# Wollongong Local Planning Panel Assessment Report | 3 November 2020

<b>WLPP No.</b>	Item No.3
<b>DA No.</b>	DA-2019/1356
<b>Proposal</b>	Residential - Eight storey residential flat building comprising 14 residential units over two levels of basement carparking.
<b>Property</b>	9-11 Park Street, Wollongong
<b>Applicant</b>	PRD Architects
<b>Responsible Team</b>	Development Assessment and Certification - City Centre Team (MJ)

## ADDENDUM REPORT

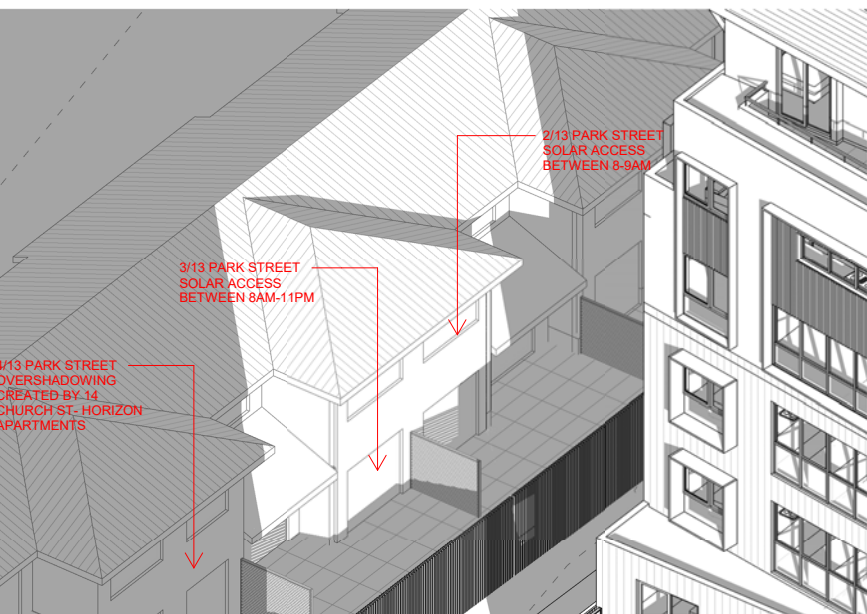
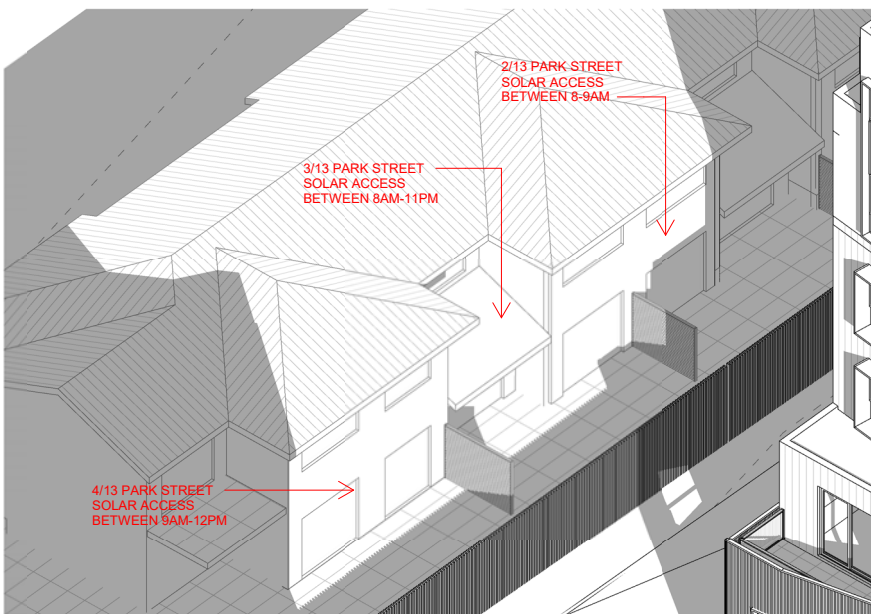
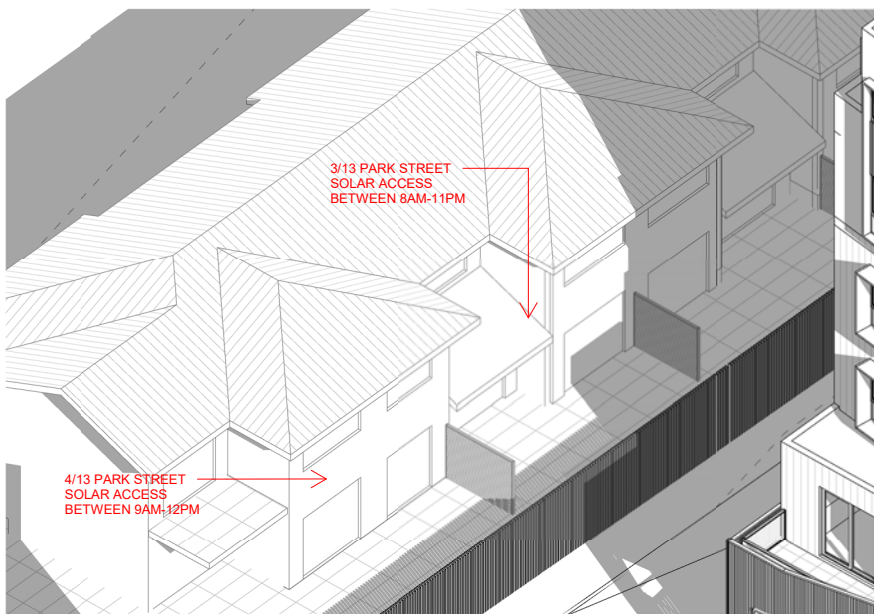
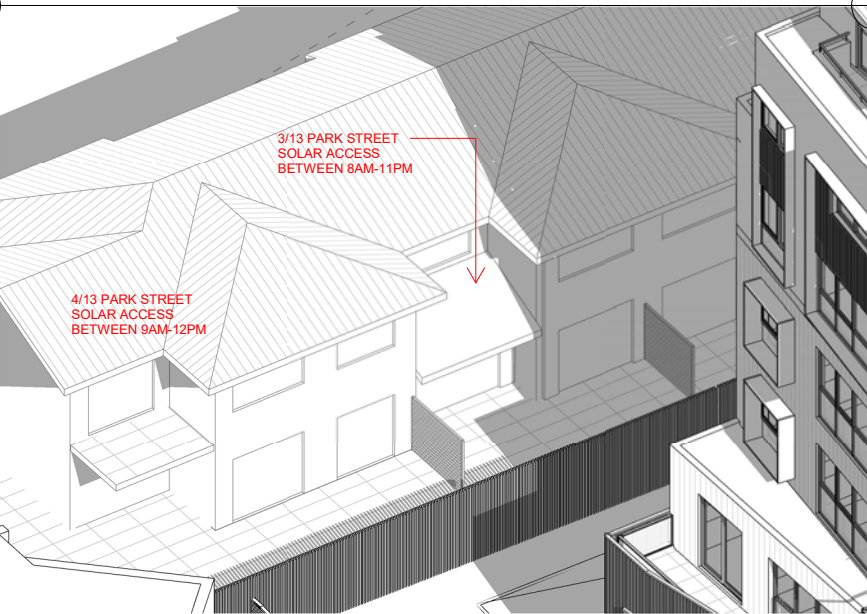
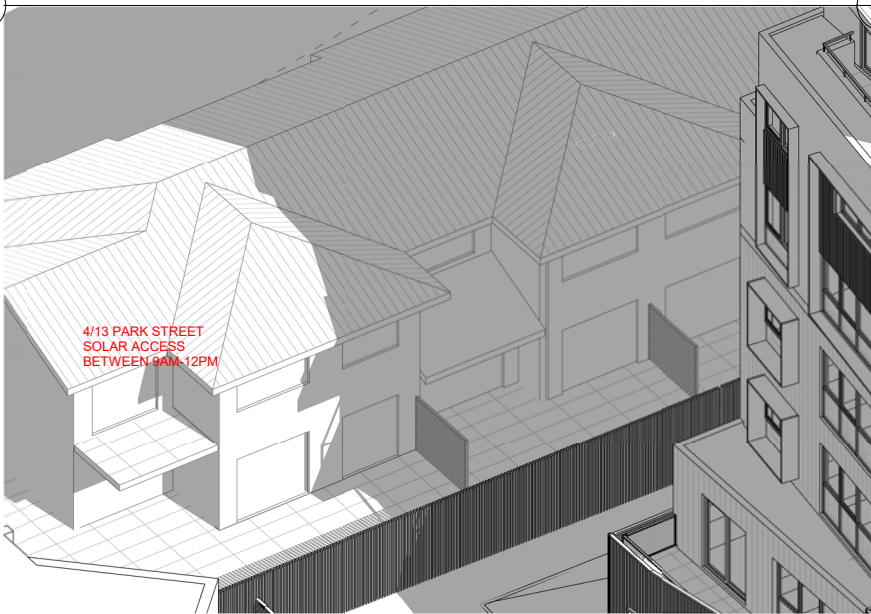
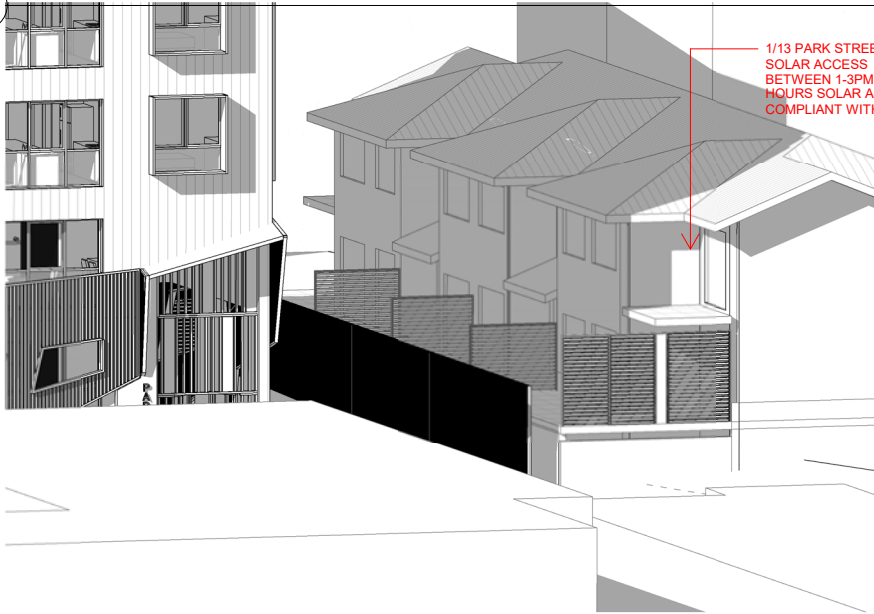
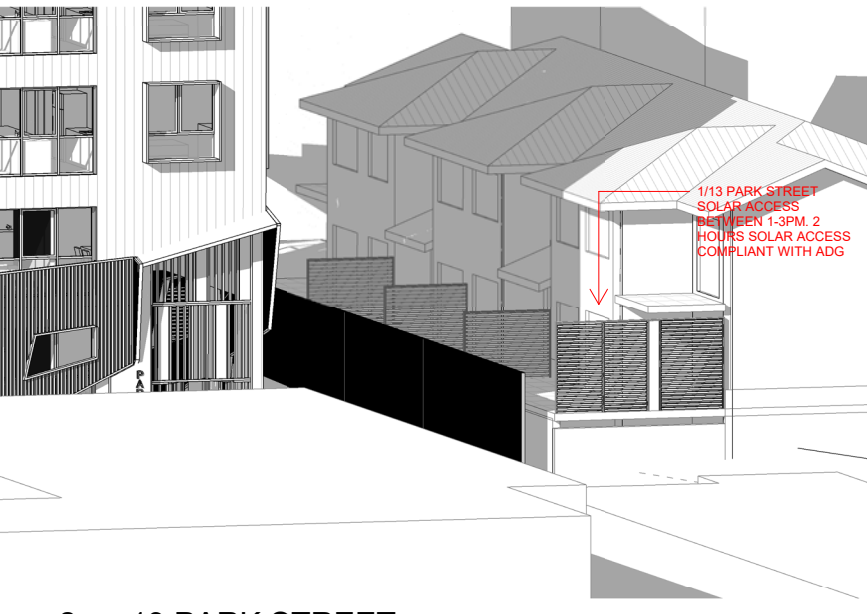
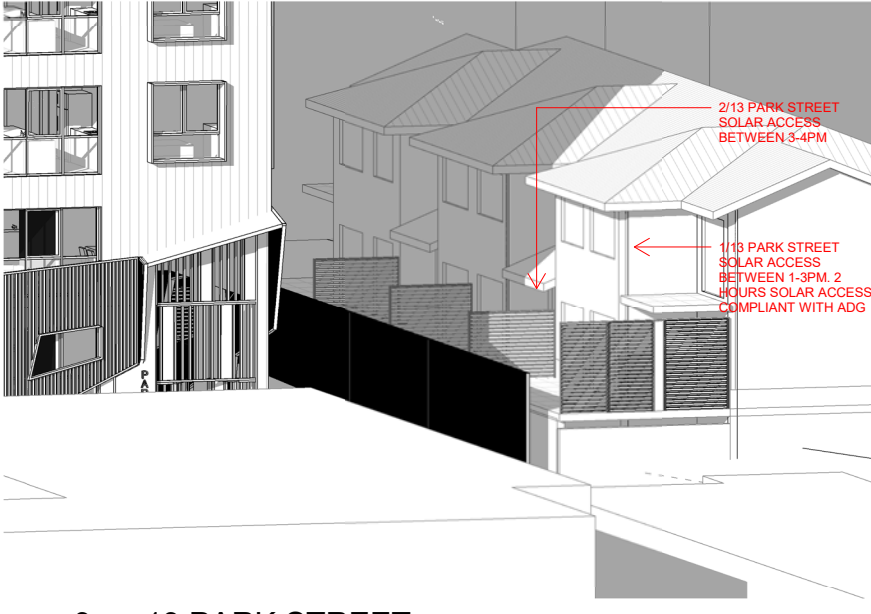
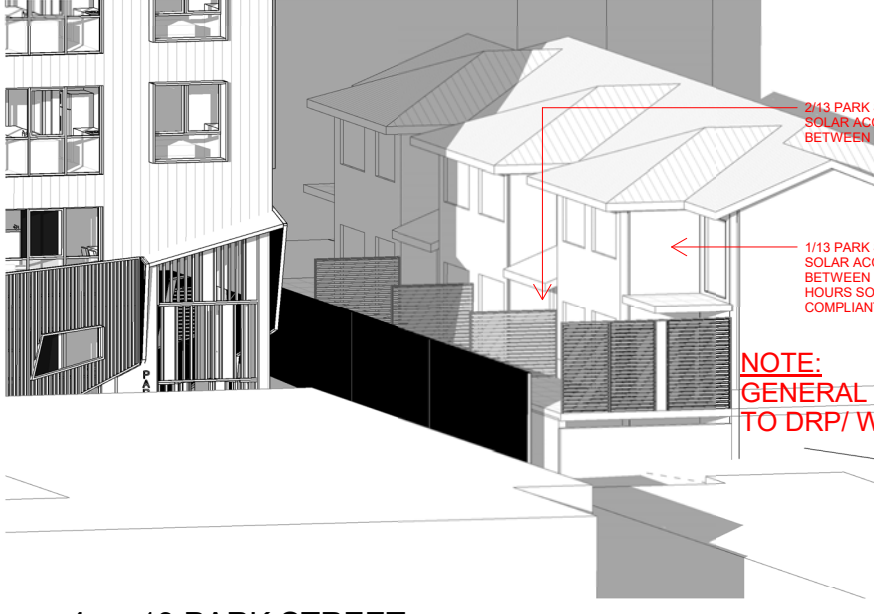
**3. Review the design to remove elements which add to the extent of overshadowing of 13 Park Street. This may involve removal of elements fronting Park Street and increasing the rear setback. It may also involve increasing height but reducing the footprint to improve the solar access to the south.**

Revised shadow diagrams have been provided demonstrating solar access provided to windows of living or POS areas of 13 Park Street, as follows:

Subject to this redesign, considering the amendments made to the building design to increase solar access, ADG requirements and direction from the Planning Principle, the proposal has satisfied the requirement from the Panel.

Figure 1 Extract of Ground Plan for No 7 Park Street

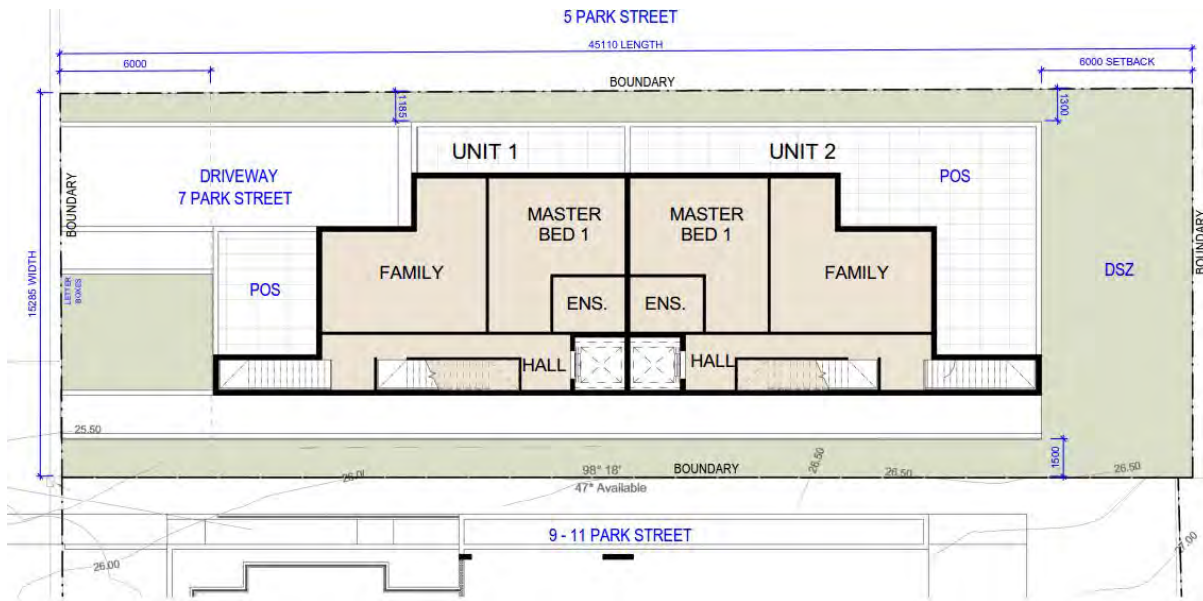
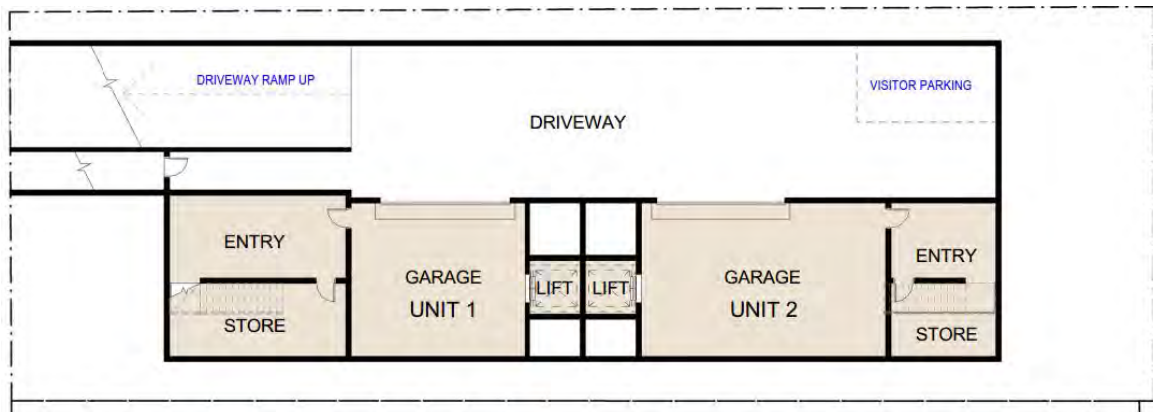
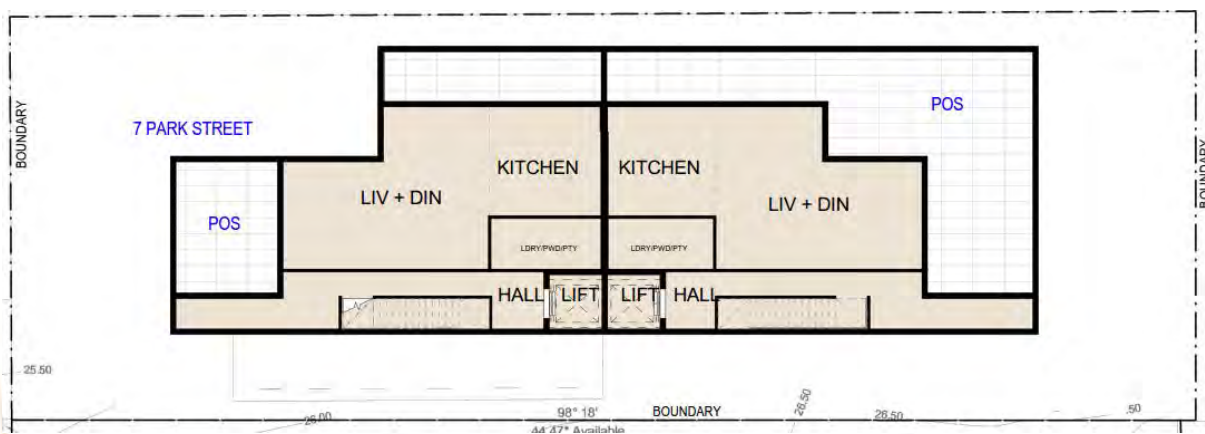
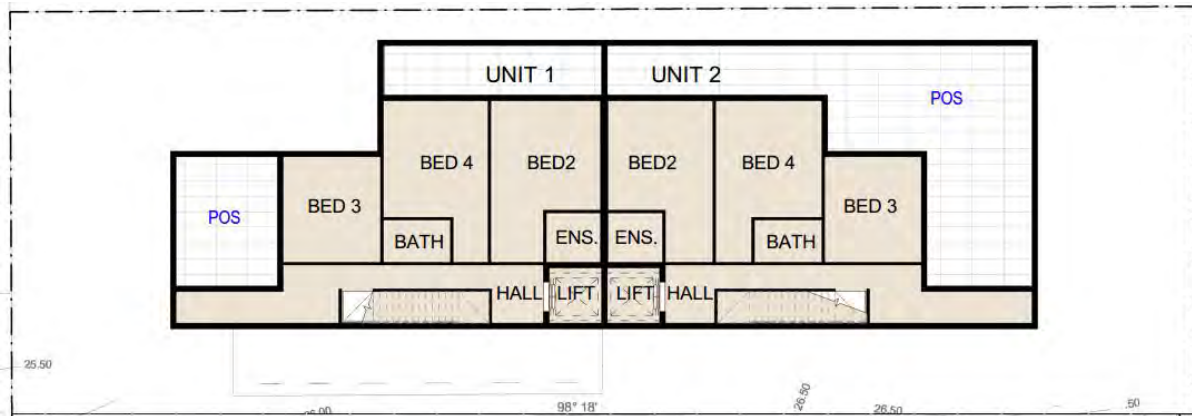
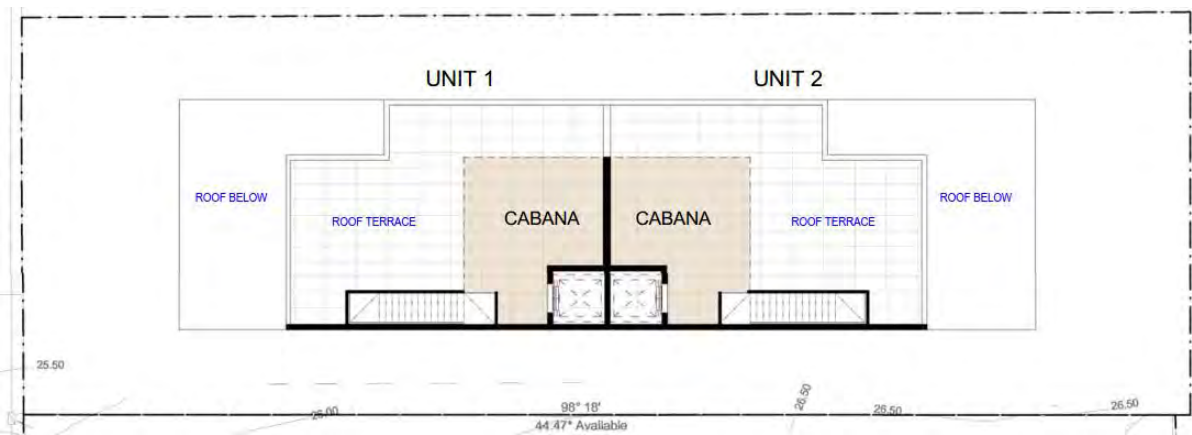
- 1. Details to establish that 7 Park Street is not isolated having regard to the relevant Planning principle. The fact that No's 5 and 7 Park Street are in the same ownership does not, in the view of the Panel, necessarily result in No 7 not being isolated.**

PRD Architects has developed a potential design for No. 7 Park Street reference in plans no. DA28-30. The site could contain a significantly sized dual occupancy being three storeys with a basement parking. An extract of the development potential can be seen below.

The proposed development for No. 7 Park Street demonstrates that the subject site can be developed and remain consistent with the objectives of the relevant planning controls. The proposed dual occupancy has been orientated to the north with no openings creating privacy concerns on the southern elevation. The GFA of the proposed dual occupancy and the height of the proposed development are below the FSR and Building Height Controls applicable to the site. This reduced development outcome is accepted in response to the smaller site width and infeasibility of site amalgamation. However, the design is responsive to the residential flat building character of the area and responds orderly economic use of this well located site.
